# NOTICE OF DECISION

## DECISION OF THE PLANNING ADMINISTRATOR

REPLAT TENTATIVE PLAN CASE NO.: REP25-03

**REQUEST:** An application for a Tentative Replat to consolidate Lots 14 and 15 of Mapleton Addition Subdivision resulting in a single lot totaling 18,600 square feet (0.43 acres) in size, zoned CR (Retail Commercial), and located at 2710 Broadway Street NE (Marion County Assessor's Map and Tax Lot Number: 073W14BB/4901).

# PROPOSED REPLAT

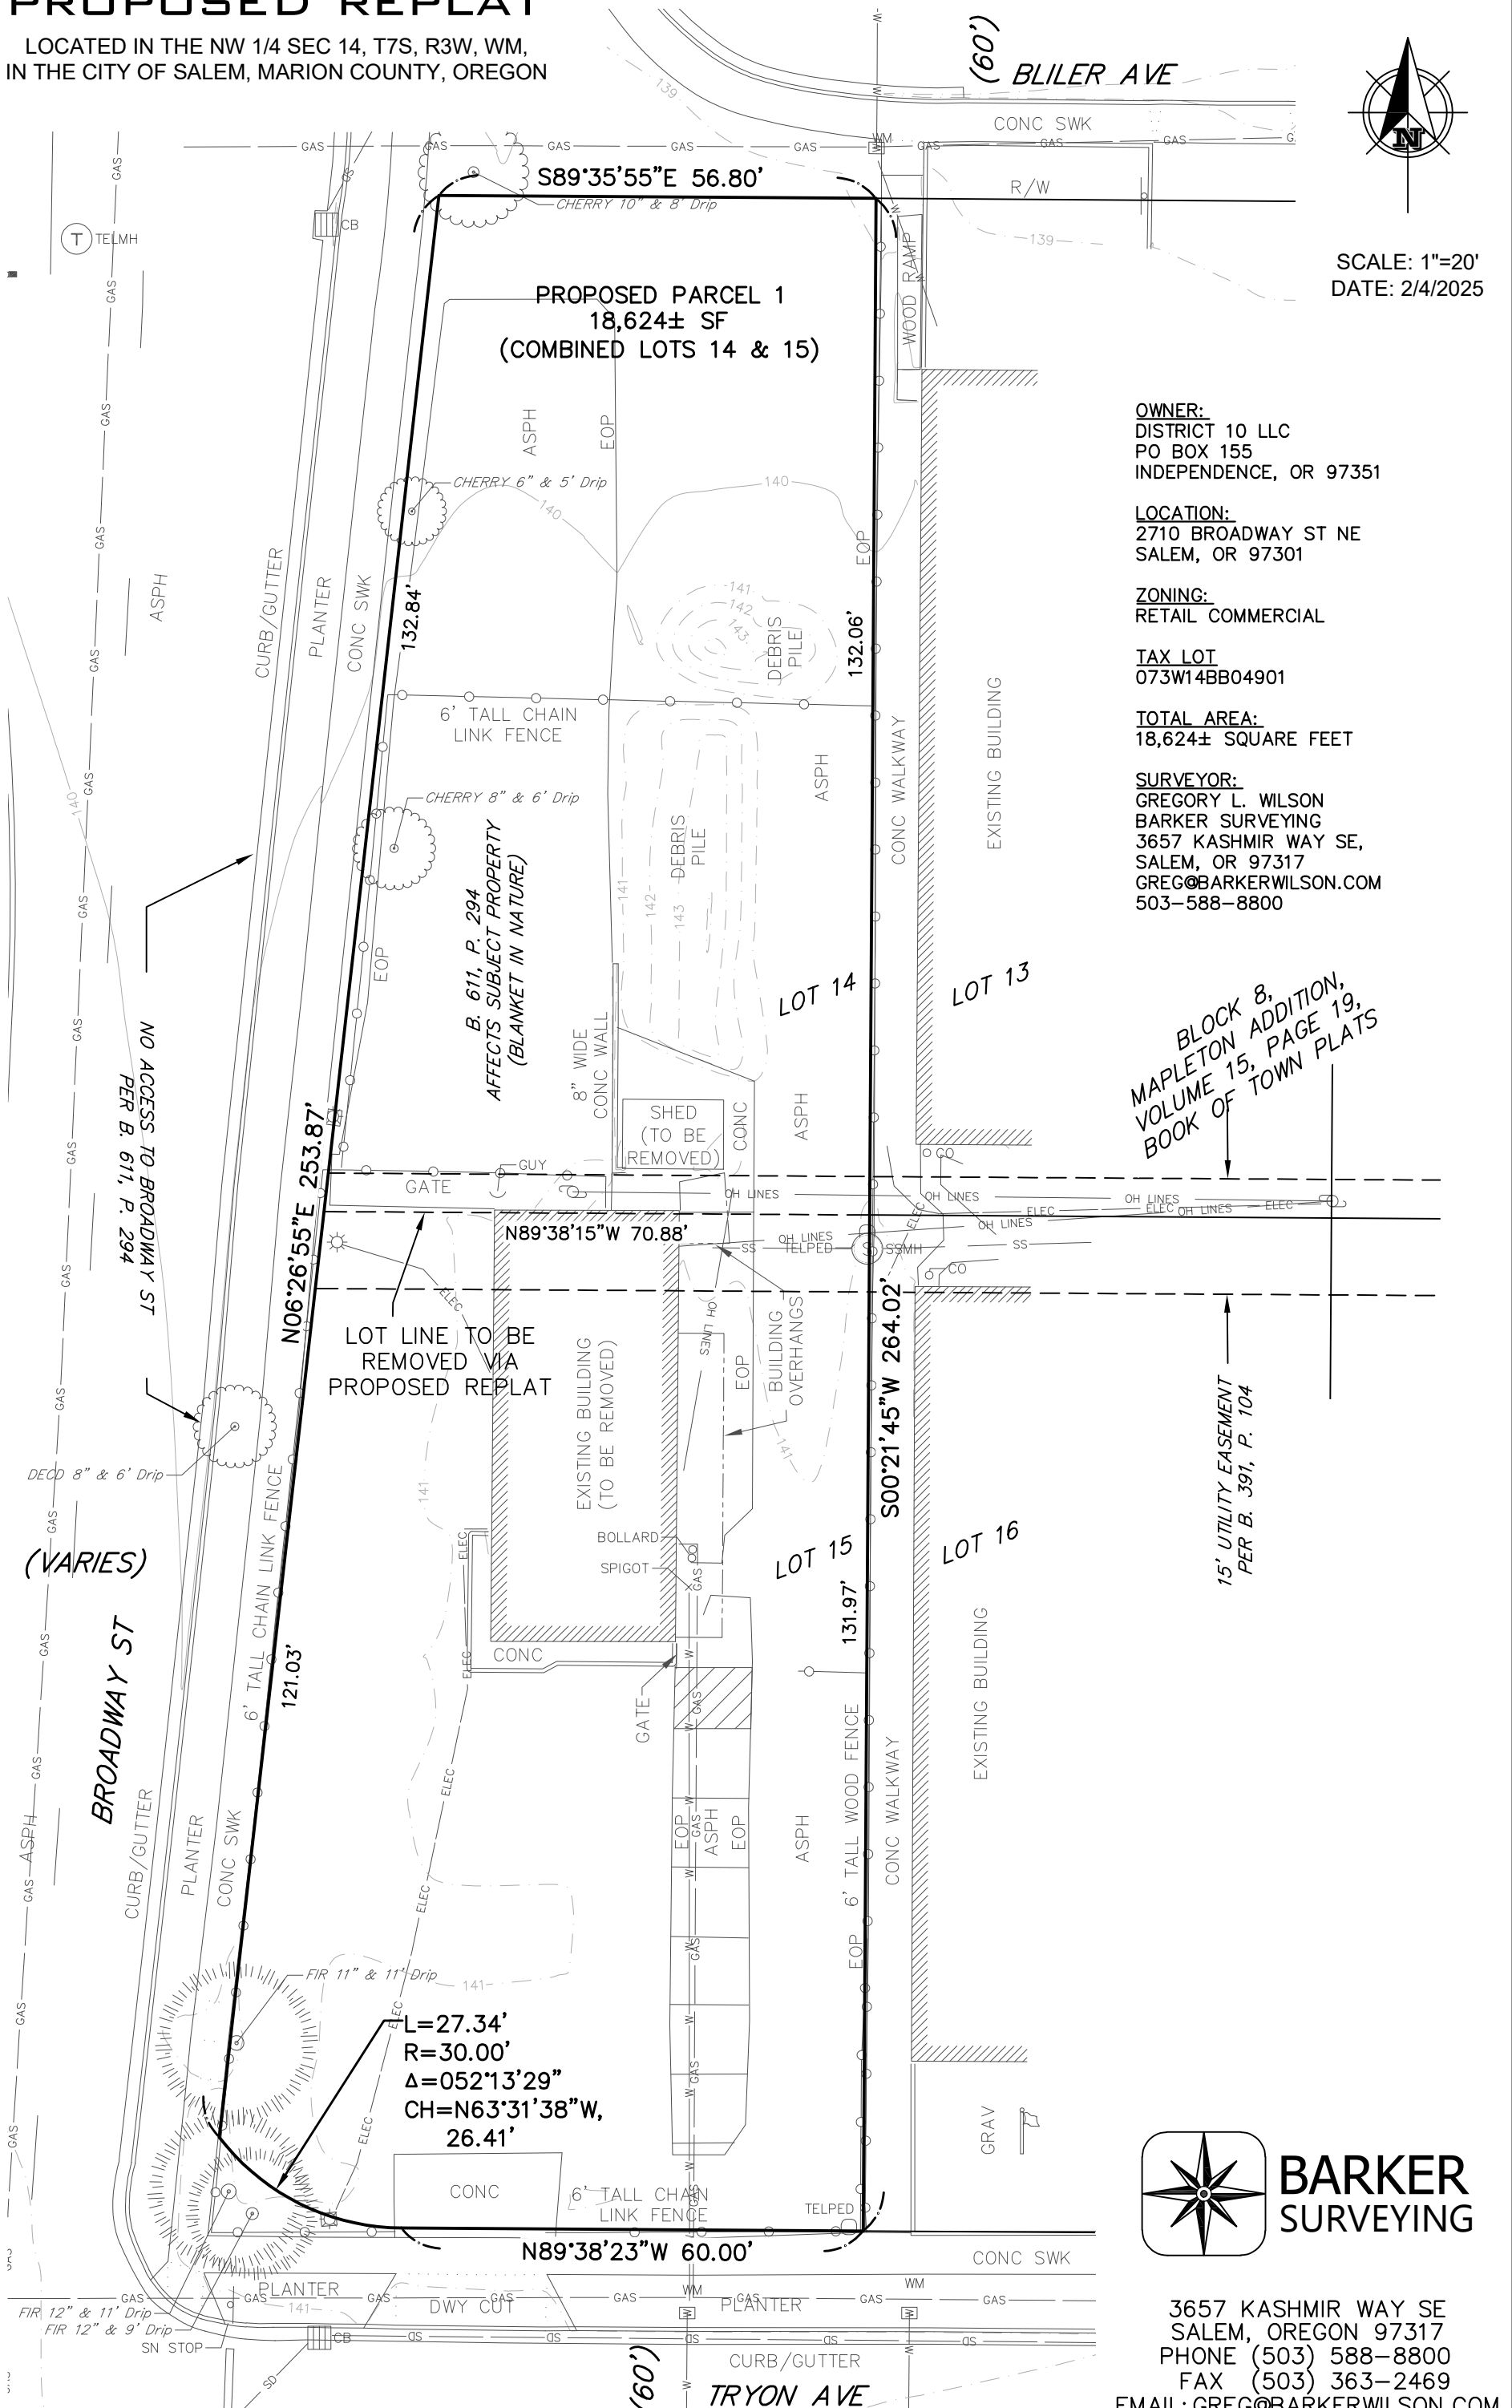
There is an existing public sanitary sewer main that terminates on the subject property, at the eastern property line. This sanitary sewer main is located in a public utility easement that extends from the eastern property line to the western property line, through the subject property. The public sanitary sewer main does not, however; extend the width of the property, it terminates at the eastern property line. According to SPR-ADJ-DAP23-33, At time of building permit review, the unused portion of this easement may be quitclaimed. As a condition of approval, all existing and proposed easements shall be shown on the final plat.

The title report indicates there are existing easements that are not shown on the tentative replat plan. All existing and proposed easements shall be shown on the final plat. As such, the above condition applies.

There is an existing public sanitary sewer main that terminates on the subject property, at the eastern property line. This sanitary sewer main is located in a public utility easement that extends from the eastern property line to the western property line, through the subject property. The public sanitary sewer main does not, however; extend the width of the property, it terminates at the eastern property line. According to SPR-ADJ-DAP23-33, At time of building permit review, the unused portion of this easement may be quitclaimed. As a condition of approval, all existing and proposed easements shall be shown on the final plat.

**Condition 1:** Show all existing and proposed easements on the final plat.

**Condition 1:** Prior to final plat approval, show all existing and proposed easements on the final plat.

**Condition:** Show all existing and proposed easements on the final plat.
